RE: EnviroChem Superfund site
Revised Response Action and Tentative Schedules

ENVIRO-CHEM REVISED RESPONSE ACTION (RRA)
September 30, 1993

REVISED RESPONSE ACTION

ECC SUPERFUND SITE

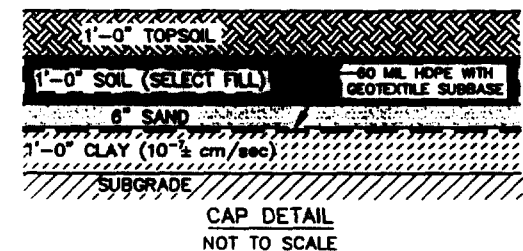
The RRA is shown on Figure 1. Differences in the selected response action, as described in Exhibit A to the Consent Decree, and the RRA are as follows:

The RRA includes excavation of the southern part of the site, including the concrete pad, aggregate and subsurface soils, to an average depth of about 8 feet below ground surface. Actual excavation depth may be greater or less than 8 feet and will be determined by reference to soil removal criteria. The soil removal criteria which will be similar to Indiana's UST practice, will be proposed to EPA and IDEM. All of the approximately 10,000 cubic yards of soil projected to be involved will be kept on site and shifted to the northern part of the site. The 3,500 cubic yards of concrete and aggregate materials also will be shifted to the northern portion of the site (or may be disposed of on or offsite.) The excavation will be backfilled to grade with clean fill.

The RRA will employ SVE over the northern portion of the site but not the southern portion, because the concrete pad and subsoils from the southern part of the site will have been shifted for on site treatment to the northern part of the site. The excavation area will be backfilled with clean soils and will not require SVE.

The total site area inside of the remedial boundary is 3.1 acres. The concrete pad area referred to is approximately 0.75 acres. The area of SVE for the RRA is approximately 2.35 acres.

The RRA includes a vertical barrier between the area of excavation and the area of SVE activity. The barrier would minimize the potential for migration of contaminated water and vapors between the two areas.

A cap as required by the Consent Decree, Exhibit A, will be placed over the SVE Area only, approximately 2.35 acres in the RAA. The clean backfill in the southern portion of the site negates any need for a cap in that area. The timing of the installation of the cap will be determined by the final plans and specifications as appropriate for the SVE system selected with EPA's approval. Depending on the system, the cap may be installed before or after installation of the SVE system.

Long-term monitoring proposed for the RRA includes three onsite till wells, four offsite till wells, four sand and gravel wells, and two surface water stations as indicated on Figure 1 (attached).
